# Access Compliance Report

## Public Rights-of-Way

### (Curb Ramps)

Intersection ID: N/A	Main Street: MCREE_RD	Cross Street: SISKEY_PY	Location: NE
ADA ID: 261F73F2B0BC	Ramp Type: PerpDiag	Initial Pass/Fail: Fail	Overall Compliance: No
		Severity Score: 22.5

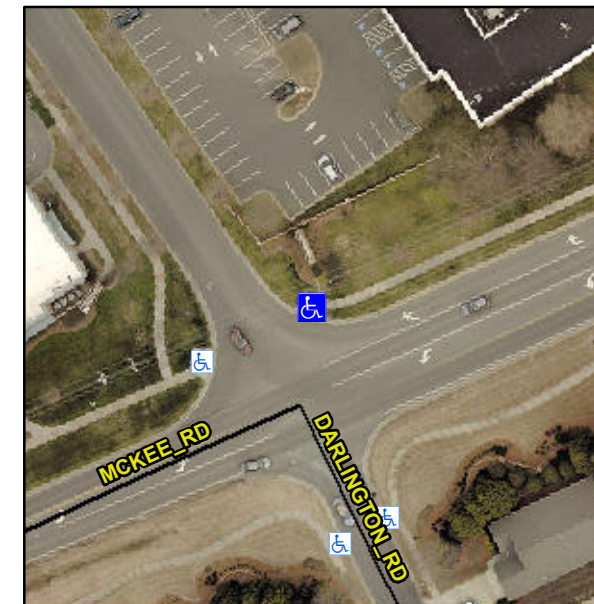
**Not Found, R304.5.1, R304.2.2, R304.5.3**

Compliance	Description	Data	Compliance	Description	Data
N/A	Ramp Length (in)	61.0	No	Ramp Slope (%)	9.3
No	Ramp Width (in)	46.0	No	Ramp XSlope (%)	2.3
N/A	Flare Type LT	N/A	N/A	Flare Type RT	N/A
N/A	Flare Slope LT (%)	N/A	N/A	Flare Slope RT (%)	N/A
N/A	Flare Traversable LT?	N/A	N/A	Flare Traversable RT?	N/A
N/A	Landing Length (in)	N/A	N/A	DWS Provided?	N/A
N/A	Landing Width (in)	N/A	N/A	DWS Contrast?	N/A
N/A	Landing Slope (%)	N/A	N/A	DWS Length (in)	N/A
N/A	Landing X Slope (%)	N/A	N/A	DWS Full Width?	N/A
N/A	Landing Curb? (Y/N)	N/A	N/A	DWS Offset (in)	N/A
N/A	Shared Landing?	N/A			
N/A	Gutter Ponding?	N/A	N/A	Gutter Slope (%)	N/A
N/A	Gutter Lip Ht (in)	N/A	N/A	Gutter X Slope (%)	N/A
N/A	Painted X Walk1?	No	N/A	Painted X Walk2?	No
	X Walk 1 Direction	To SW		X Walk 2 Direction	To SE
N/A	X Walk 1 Width (in)	N/A	N/A	X Walk 2 Width (in)	N/A
	X Walk 1 Slope (%)	4.5		X Walk 2 Slope (%)	2.7
	X Walk 1 X Slope (%)	1.6		X Walk 2 X Slope (%)	3.2

**Remove & Replace Curb Ramp With Two New Directional Ramps or Equivalent.**
